Control Message Update v2

Dave Olsen 7/19/2012

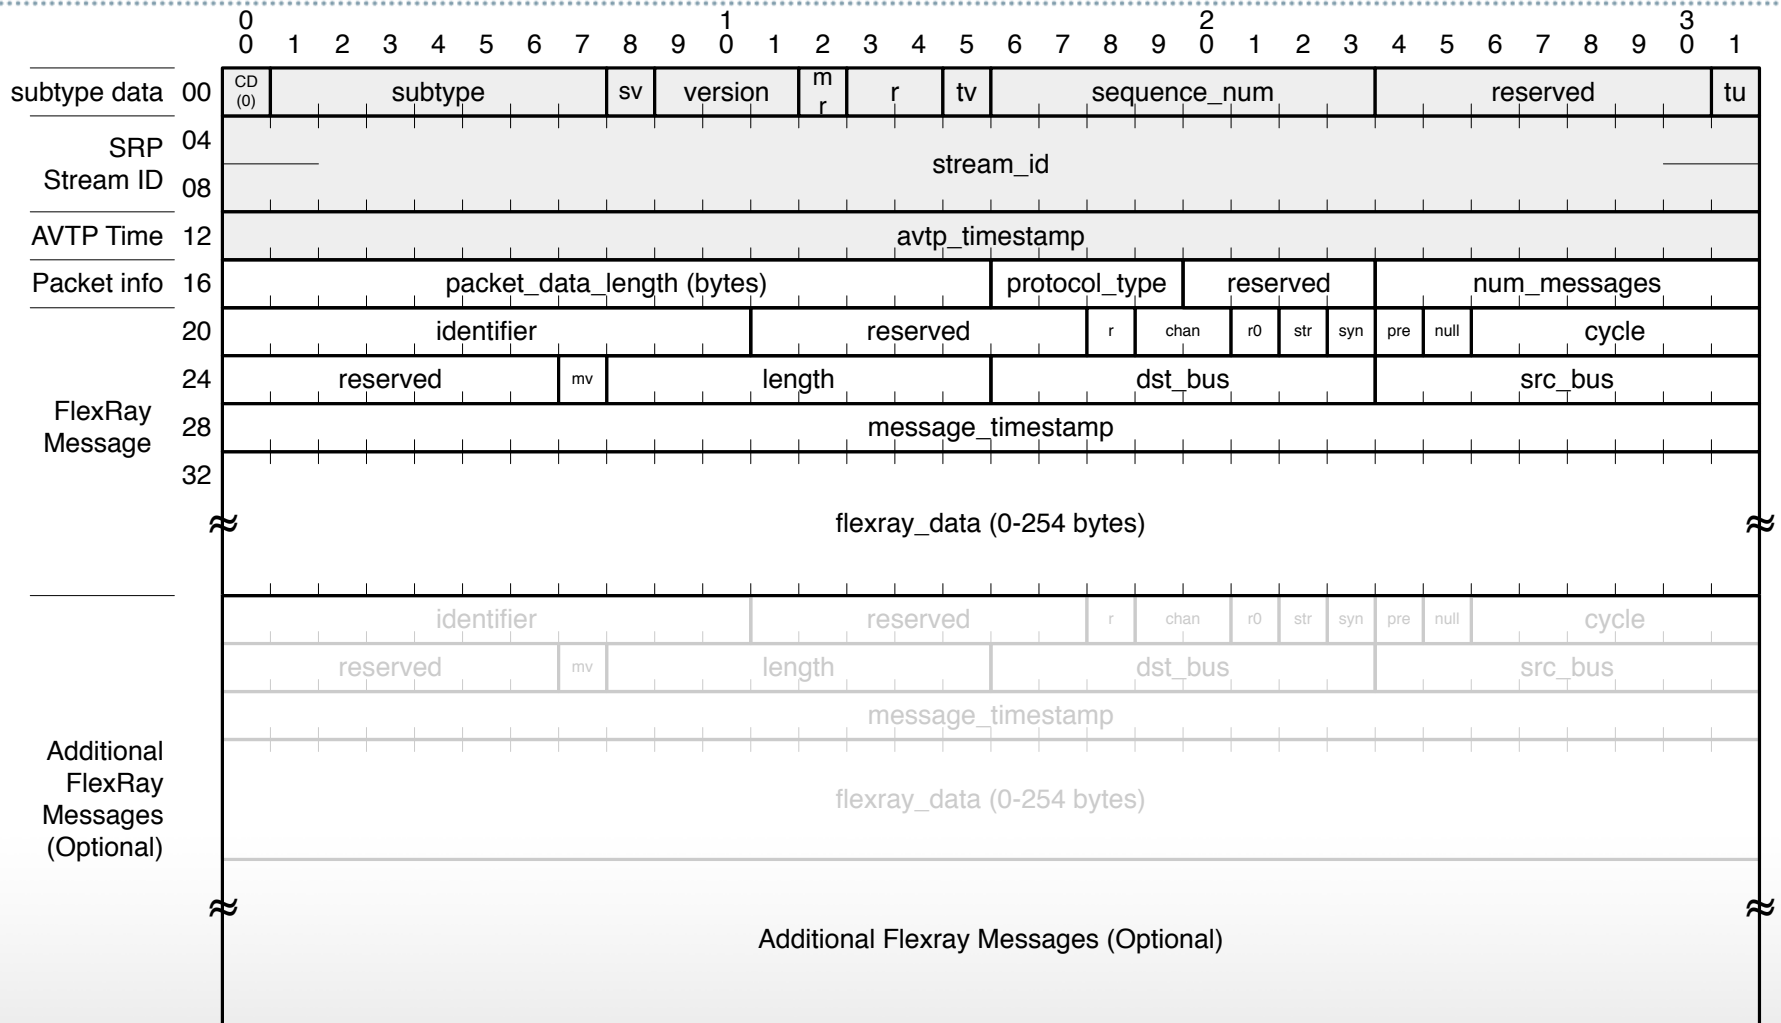
-
- **Source and Destination Bus fields change to 8 bits**
 - **Timestamp per message**
 - **Normalize Length fields**
